HISTORIC AND DESIGN REVIEW COMMISSION

HDRC CASE NO: 2015-240
ADDRESS: 532 DAWSON ST /
417 N MESQUITE
LEGAL DESCRIPTION: NCB 568 BLK 17 LOT E 2.08 FT OF N 107 FT OF 7 & N 107 FT OF 8
ZONING: RM4 H
CITY COUNCIL DIST.: 2
DISTRICT: Dignowity Hill Historic District
APPLICANT: Logan Fullmer
OWNER: Logan Fullmer
TYPE OF WORK: New construction of 5 detached units
REQUEST:

The applicant is requesting for conceptual approval to construct four detached, single family units.

SCHEMATIC SITE PLAN -
4 UNITS

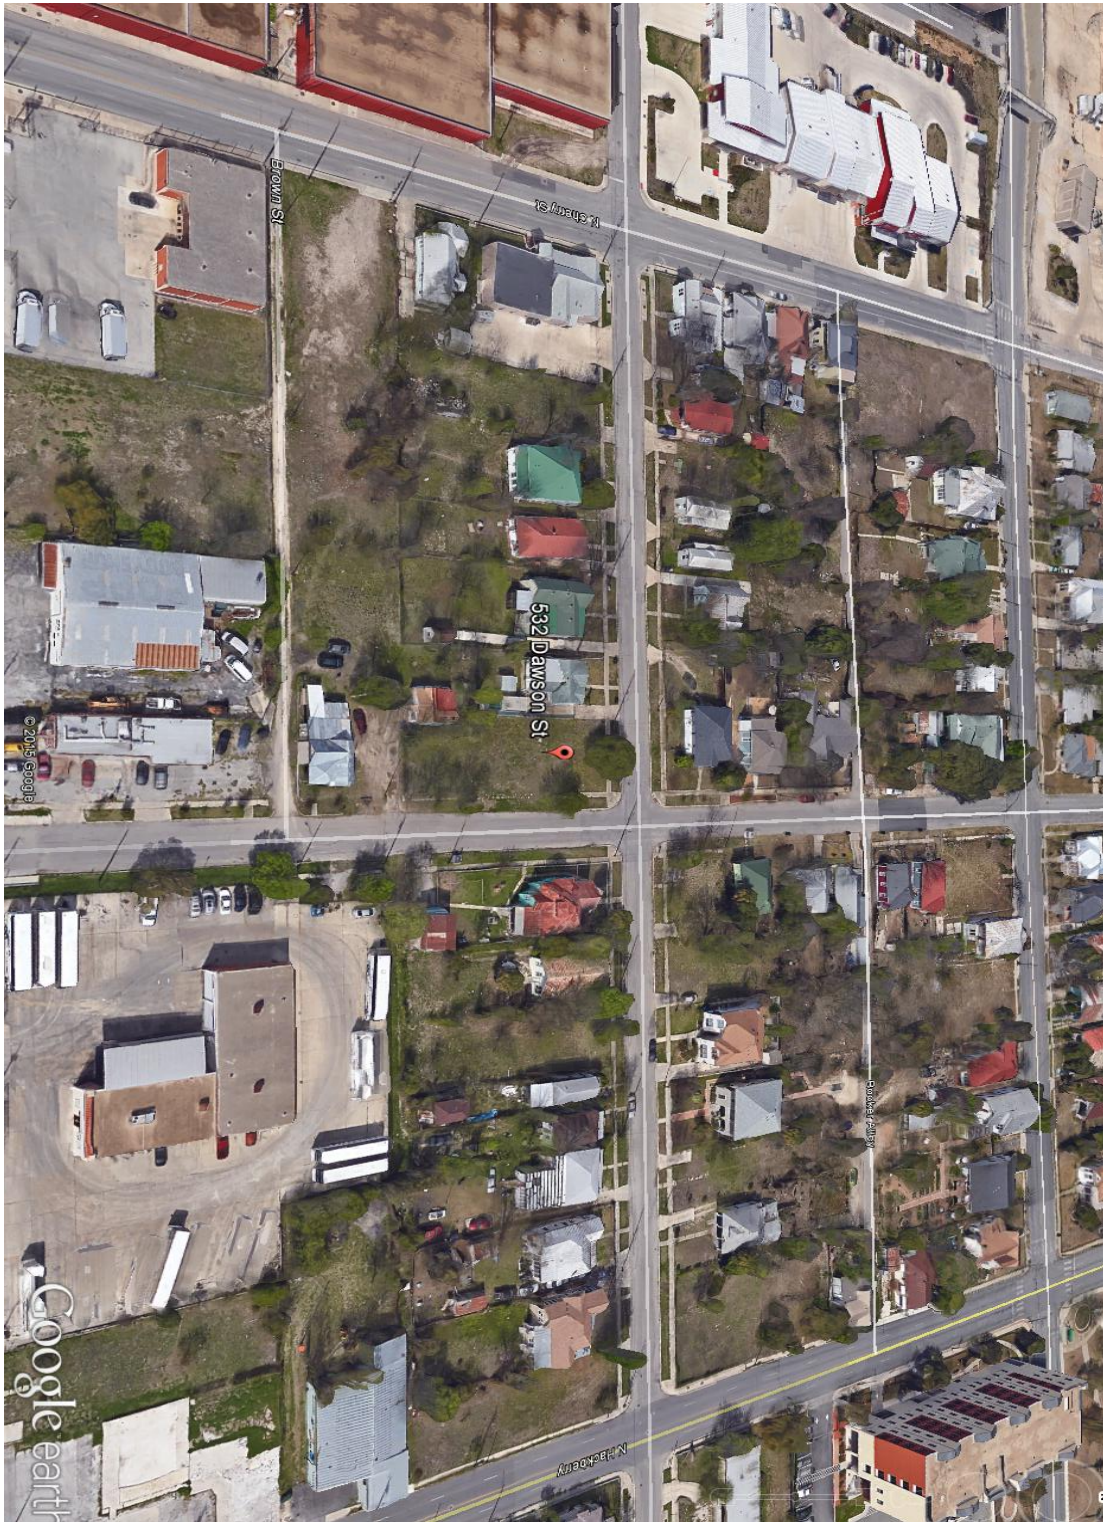
- f. The applicant has previously proposed five, detached single family units on the vacant lot at the corner of Dawson and N Mesquite, however, at this time the applicant is proposing four, detached single family units. The applicant has aligned the corner unit in a manner which is generally consistent with the setback of the historic structures found along Dawson. On N Mesquite, the applicant has aligned the front most façade elements of each structure to be consistent with the setback existing setbacks on this blockface. This is consistent with the Guidelines for New Construction 1.A.i. and ii.

- i. The Guidelines for New Construction 2.D. in regards to lot coverage states that new construction should be consistent with adjacent historic buildings in terms of the building to lot ratio and that the building footprint for new construction should be no more than fifty (50) percent of the total lot area unless adjacent historic buildings establish a precedent with a greater building to lot ratio. Previously, the applicant had proposed to construct five units presenting concern from staff regarding the overall amount of lot coverage throughout the development, however, with four units, staff finds that the applicant has presented an overall lot coverage that is not only consistent with the Guidelines, but also appropriate with the historic examples provided throughout the Dignowity Hill Historic District.

- q. According to the Guidelines for Site Elements 5.B.i., historic driveways are typically no wider ten (10) feet in width. The applicant is responsible for complying with these Guidelines regarding the width of the proposed driveways.
